CITY OF ALBUQUERQUE

September 11, 2009

**Re: Glendale Development Lot 30-B Grading and Drainage Plan
Engineer's Stamp dated 8-8-09 (B20/D20)**

GRADING & DRAINAGE PLAN

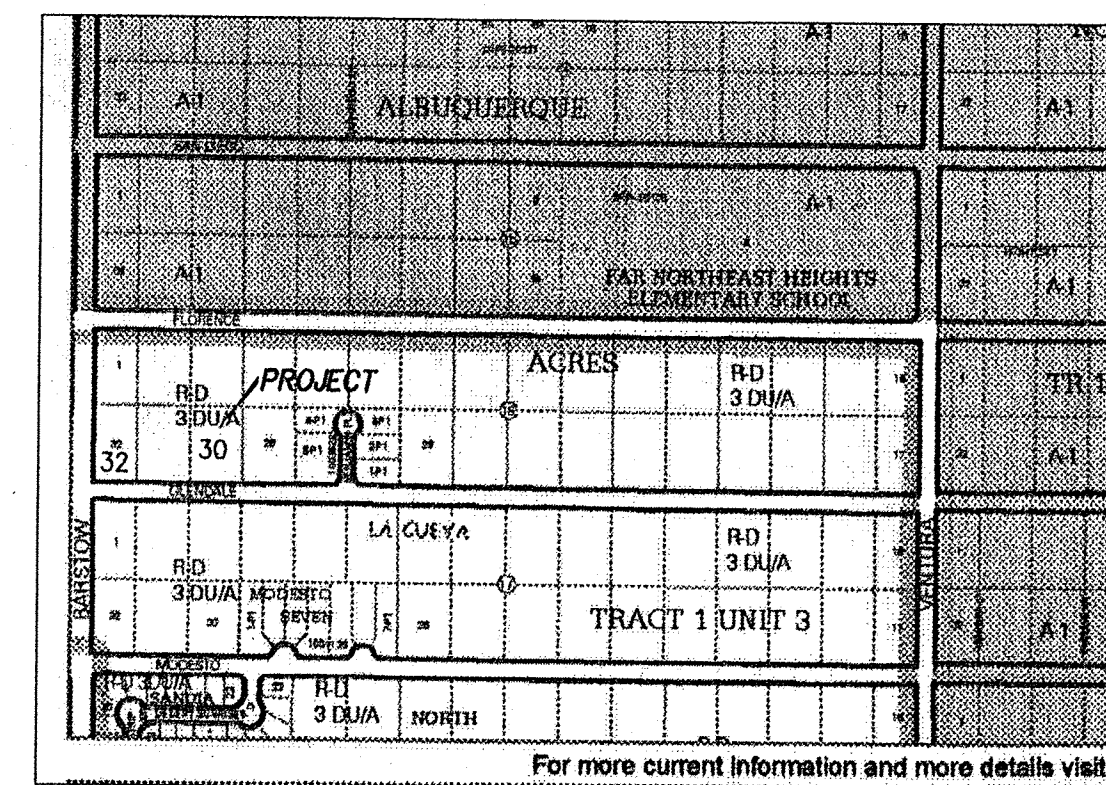
Based upon the information provided in your submittal dated 8-8-09, the above referenced plan is approved for Building Permit. Please attach a copy of this approved plan to the construction sets prior to sign-off by Hydrology.

Also, prior to Certificate of Occupancy release, Engineer Certification of the grading plan per the DPM checklist will be required.
